Annex 2 – Technical Note: Assessment of travel times and accessibility to health facilities for the Proposed Ansty Farm Development (Site 736)

Prepared by M T Hurley for and on behalf of residents of Broxmead House, Broxmead Lane, Cuckfield, RH17 5JH in response to the Mid Sussex District Plan Review 2021-2039 Regulation 18 Public Consultation.

19 December 2022

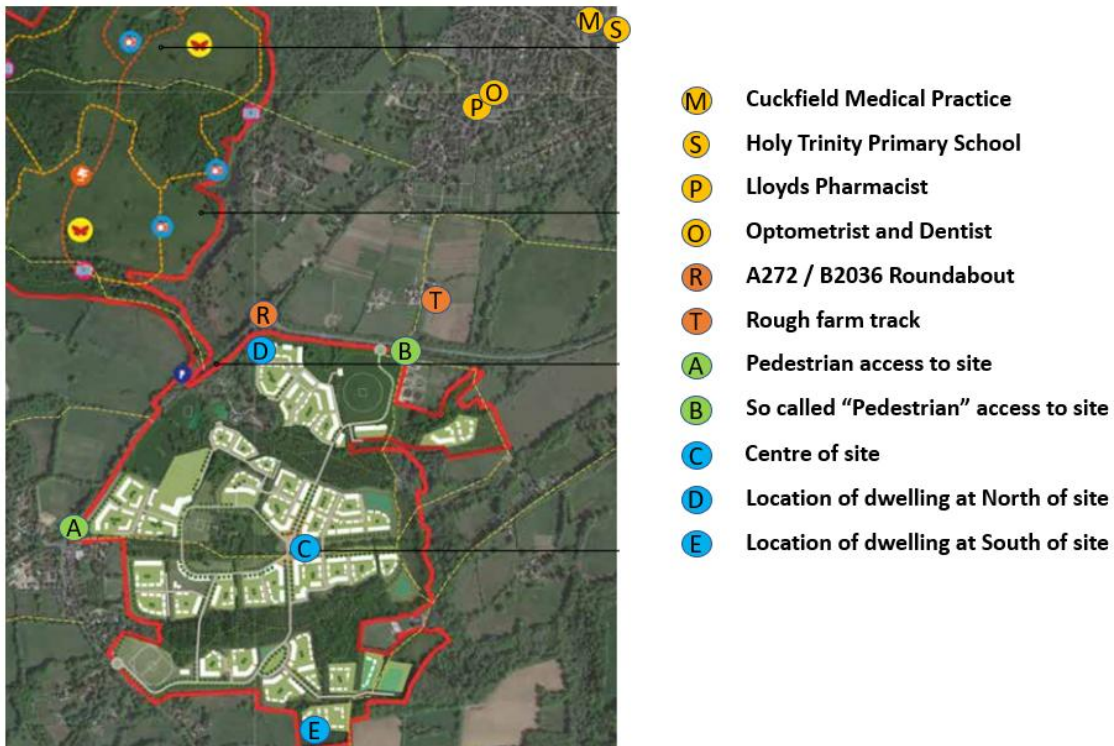
1. The proposals for the Site rely on a number of "existing local services" which are located in Cuckfield. The proposed Site does not include the supply of critical health services for example a doctors's surgery, a pharmacist, a dentist an optromatist. Residents at the proposed Site would need to travel to Cuckfield to obtain access to these services. Figure 1 shows critical services provided at Cuckfield along with various other annotations. We will consider the practicalities of accessing services such as these from the proposed Site.

- North of the Site is the busy A272. The promoters show a proposed pedestrian access (marked B) on the A272. Their Site Isochrone analysis suggests that this access point can be used by pedestrians to walk to Cuckfield either by using the footpath and unmade track (marked T), or walking first alongside the A272 westwards (for about some 450 meters on the grass verge), then along the B2036. The footpath and track are unmade and are unsuitable for pushchairs or wheelchairs. The footpath and track are not lit. Crossing the A272 at that point would be dangerous. There is a grass verge runs alongside the busy A272 which would not be possible for wheelchair use. There is no paved footpath. There is no lighting. The promoter does not address any of these points in the proposals and must assume that this access is not to be used by residents at the site with pushchairs or wheelchairs.

6. We do not know how the promotor arrived at these figures.
7. As we have shown the proposed Pedestrian access from point B is unsafe / discriminatory and residents of the proposed development will be required to use the primary pedestrian access (from point A at the boundary of the Site at Ansty Cross).

9. The results presented the promotor for access to critical facilities in Cuckfield from are misleading as they do not appear to take account of the need for pedestrians to use access point A and do not take into account the distance required to be travelled from the centre of the Site.

Fig 4 – Annotated Ordnance Survey map, showing the distance from location D to the pedestrian entrance to the proposed Site at Ansty (location A).

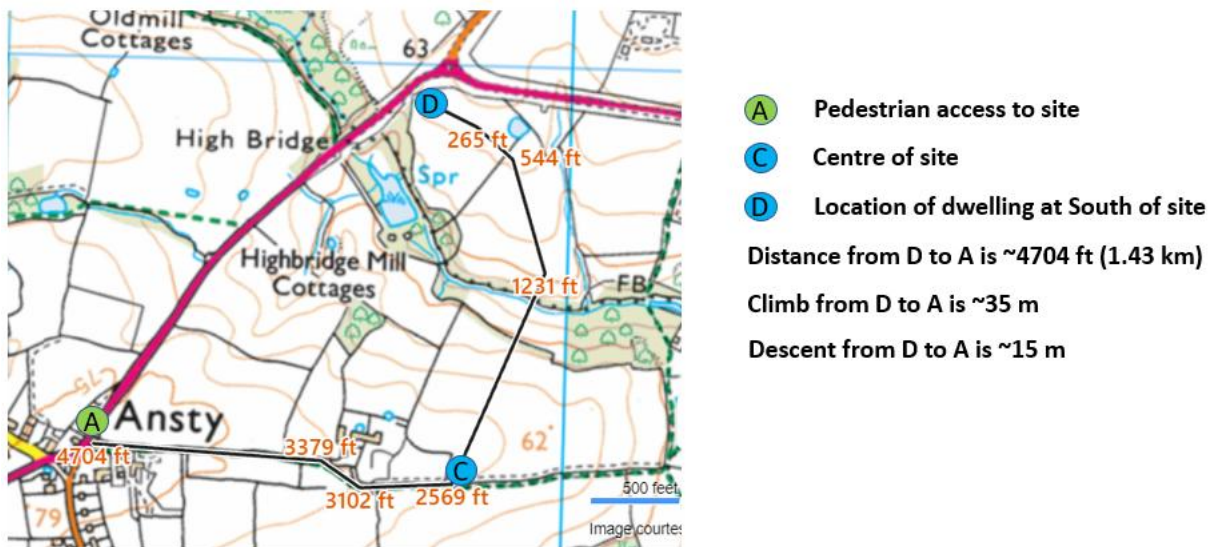
16. Here, a single parent with a pre-school child and baby in a pushchair lives in a dwelling at the North of the proposed Site at location D. He needs to go to the pharmacist (in Cuckfield at location P in Fig 1) and does not own a car. The distance to the pedestrian entrance (location A) is approximately 1.43 km with a descent of approximately 15 meters and a climb of approximately 30 metres (see Fig 4). He then needs to push the pushchair, holding the hand of the pre-school child, a further 1.93km alongside a busy road from location A to get to the pharmacist. This is a total round-trip distance of 6.7 km with 130 meters of uphill and 130 meters downhill (see Appendix A). This journey will be a serious challenge to navigate safely.

18. The design and location of the proposed development at Ansty Farm would require our single parent resident to push his baby’s pushchair alongside a busy road and travel extreme distances for his round-trip the pharmacist (circa 6.7 km) and he would have to deal some 130 meters of uphill and 130 meters downhill. The walking time for this trip at a speed of 4.6 km/hr (based on the google maps speed) would take 87 minutes. We walk slower than this and it is likely that our single parent resident pushing a pushchair and holding the hand of his pre-school child would walk slower and the round-trip would take over one and a half hours. For our single parent, the location of the proposed Site appears contrary to the provisions of MSDC Equality Impacts Assessment (EqIA) – 2022

Fig 5 – Annotated Ordnance Survey map, showing the distance from location E to the pedestrian entrance to the proposed Site at Ansty (location A).

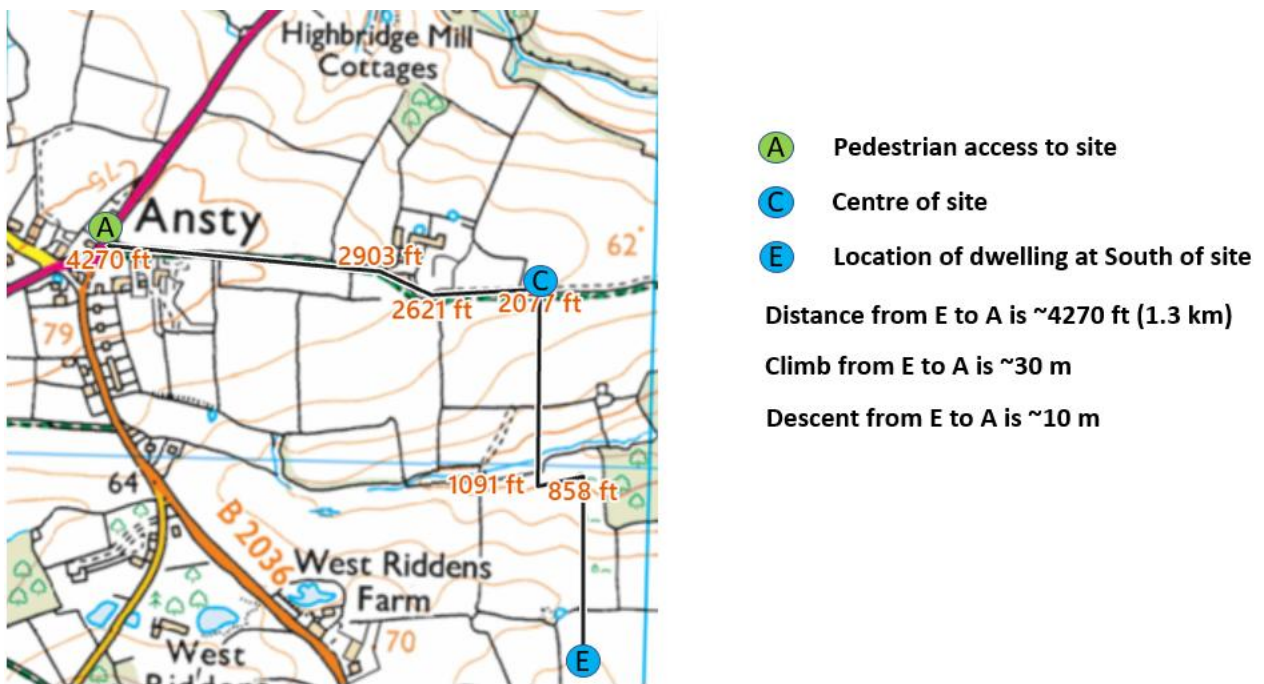
19. Here, an elderly resident who uses a stick to walk, with lives at the South of the proposed Site at location E. He needs to go to the doctors (in Cuckfield at location M) and does not own a car. The distance to the pedestrian entrance (location A) is approximately 1.3 km with a climb of approximately 30 metres and descent of 10m (see Fig 5). He then needs walk a further 2.65km from locaiton A to get to Cuckfield Medical Practice (1.93km to get to the Pharmacist (see Fig 4) and a further 0.72km to get to the doctors. This is a total round-trip distance of 7.9 km with 150 meters of uphill and 150 meters downhill (see Appendix A)

21. The design and location of the proposed development at Ansty Farm would require our elderly resident to walk alongside a busy road and travel extreme distances for his round-trip the doctors (circa 7.9 km) and he would have to deal some 150 meters of uphill and 150 meters downhill. As a sense of scale, this is greater than the ascent / descent of Ditchling Beacon from Underhill Lane in Ditchling. For our elderly resident, the location of the proposed Site appears contrary to the provisions of MSDC Equality Impacts Assessment (EqIA) – 2022

Fig A3 – Annotated Ordnance Survey map, showing the distance from the Site pedestrian entrance A to the Pharmacist (P)

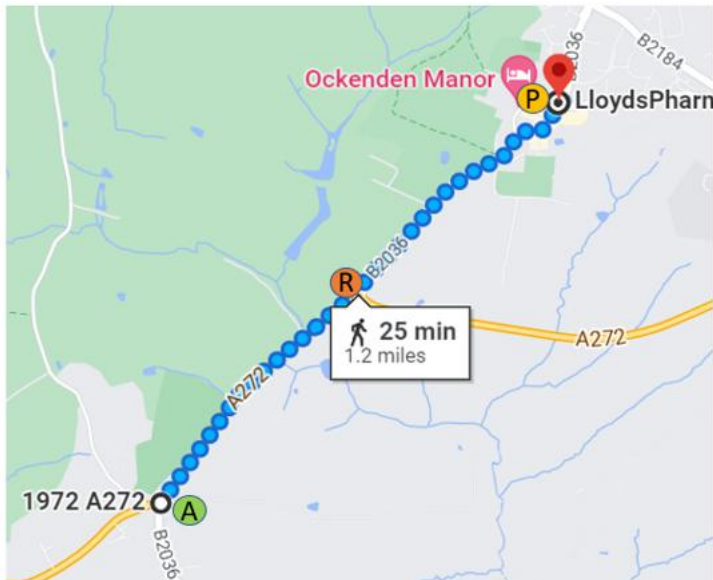
12. The distance to the pedestrian entrance (location A) is approximately 0.66 km with a climb of approximately 15 metres (see Fig 3). She then needs to wheel a further 1.93km from location A with descents of 25m and climbs of 55m to get to the optometrist and dentist (see Appendix A). This is a total round-trip distance of 5.2km with 95 metres of uphill and 95 metres downhill. Along the busy section from A to O there are some long sections (each over 100 meters in length) with gradeints of around 1 in 13

15. The design and location of the proposed development at Ansty Farm would require our disabled resident to wheel extreme distances for her round-trip the dentist (circa 5.2 km) and she would have to deal with ramps of around 1 in 13 for over 500 meters of her journey. For our disabled resident, the location of the proposed Site appears contrary to the guidance provided by the Department of Transport and the requirements of the Equality Act and the public sector Equality Duty set out in the Equality Act 2010.
